Revision: A THIS BULLETIN SUPERSEDES ALL PREVIOUS VERSIONS
May. 2014 Fig. 2, change per comments.

DISCONNECT WINDOW OPEN SIGNAL FROM MUX Prevost vehicles

On the vehicles affected by this bulletin, to cancel the DID pop-up message "windows ajar" disconnect wire 260 from MUX module A42.

Figure 1

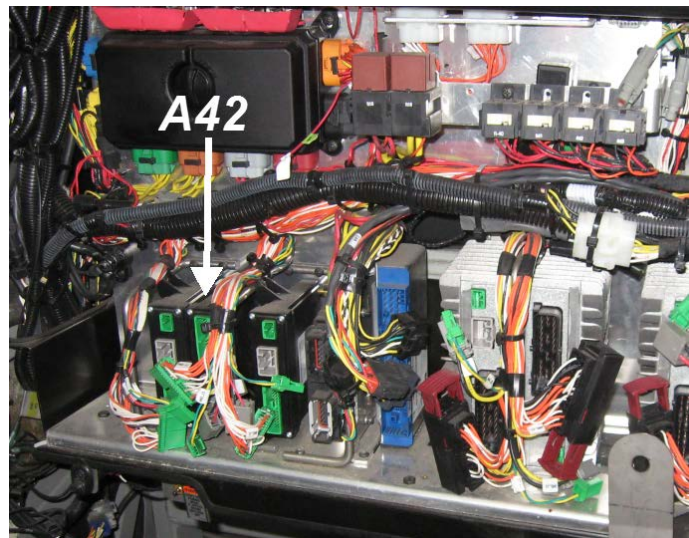
- 1) Find module A42 located in the front junction box (Fig. 1)

Figure 2

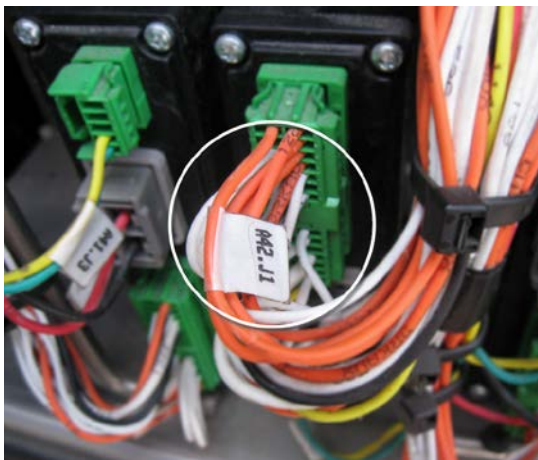
- 2) On module A42, find connector J1 (fig.2, 3) and disconnect.

Figure 4

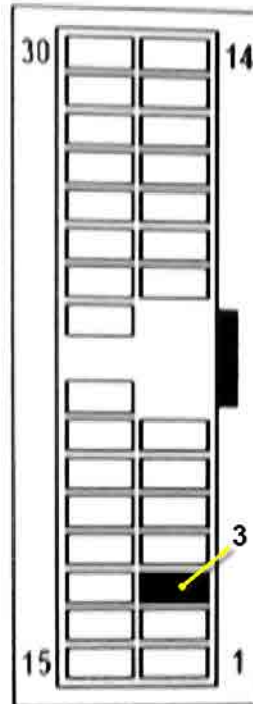
- 3) On connector J1 remove wire 260 in cavity #3. (fig. 4)

Use extractor tool 683766 and remove terminal.

Cut exposed wire and add shrink tube, to seal the wire end.

- 4) Reconnect J1
- 5) Attach 260 wire if loose.
- 6) Restore power to the vehicle and test to confirm window opening does not trigger message in the DID
